**BELL BEND NUCLEAR POWER PLANT  
PARTIAL RESPONSE TO  
ENVIRONMENTAL REQUESTS FOR  
ADDITIONAL INFORMATION  
5022, 5026, & 5036  
BNP-2010-271                  Docket No. 52-039**

Responses to Environmental Requests for Additional Information  
No. 5022 EIS 9.3-15, EIS 9.3-18 & EIS 9.3-19a  
No. 5026 EIS USACE-16  
No. 5036 EIS 9.3-32 & EIS 9.3-33  
Bell Bend Nuclear Power Plant

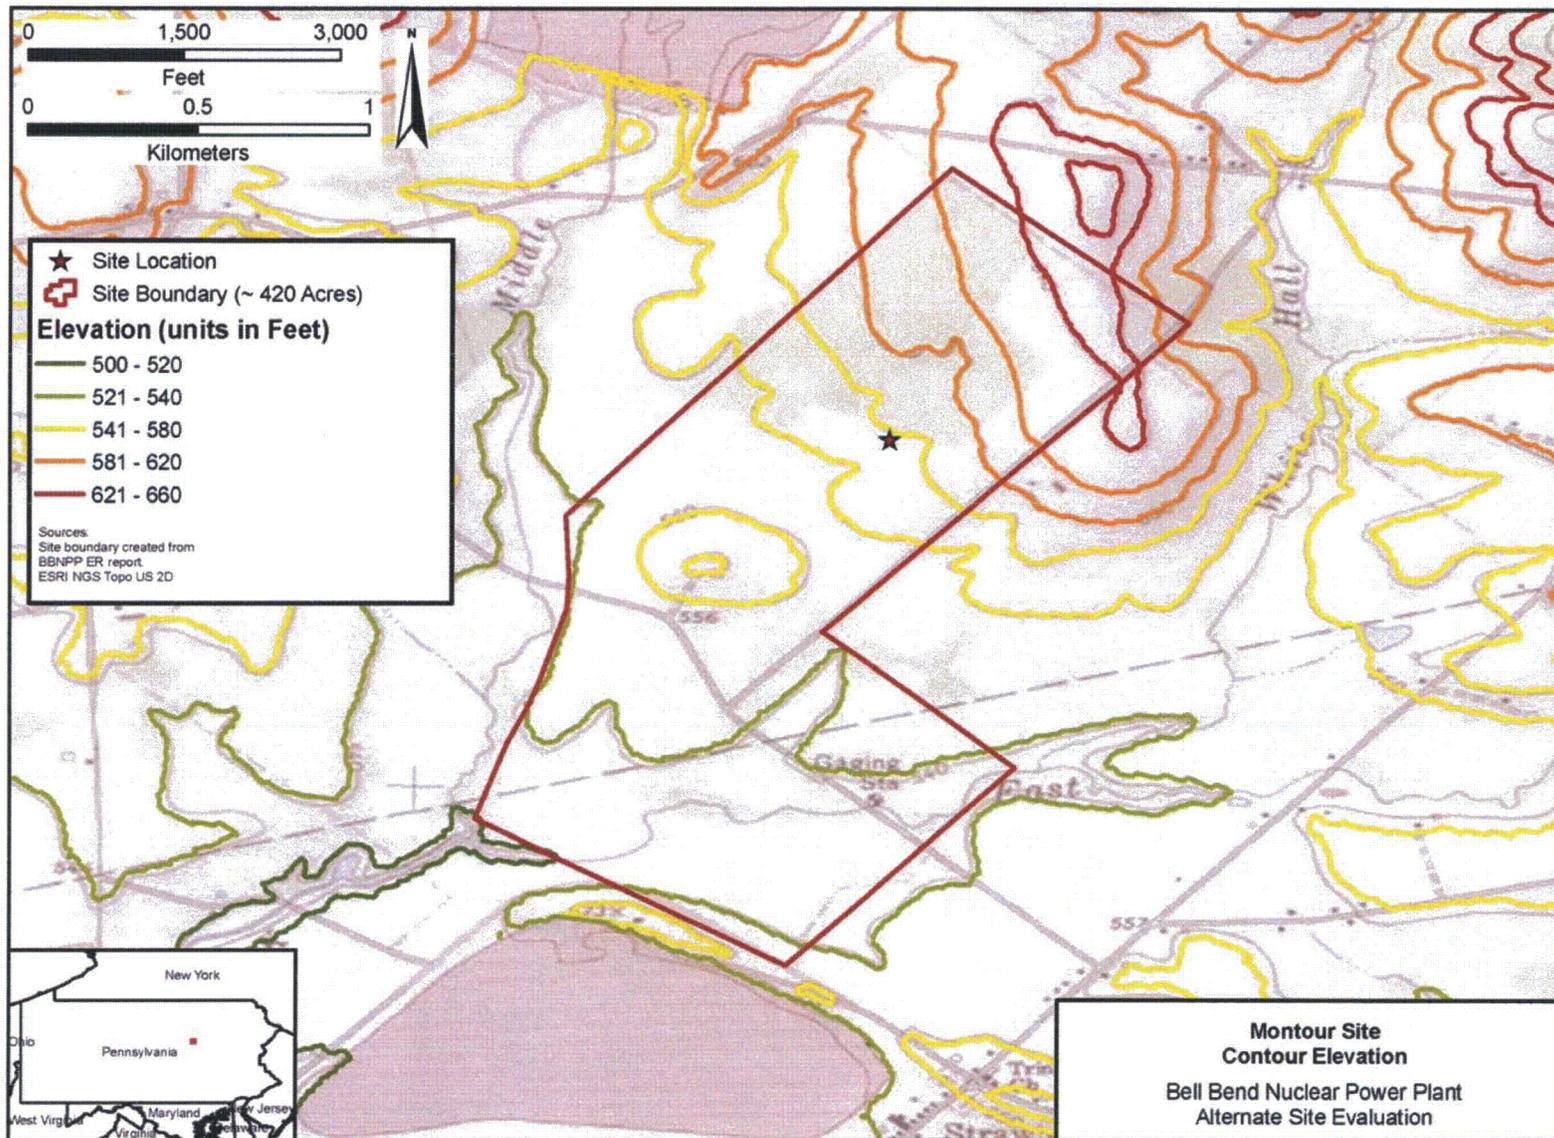
*Clarification is needed for ASER Appendix C, page C-7. Criterion 1e attributes "steep" topography to the Montour site. The Montour site visited during the initial alternative site tour did not appear to have any steep terrain.*

As stated in Criterion 1e (Montour site) on page C-7 in Appendix C of the ASER and as shown in the attached figure, "This site has steep topography with approximately 132 feet (40 m) of relief across the site, although the steeper relief is concentrated on the southernmost and northernmost portions of the site." The preliminary placement of the power block was near the center of the site and the initial alternative site tour focused on this area. See also the response to RAI No. 5022 EIS 9.3-16 (BNP-2010-251).
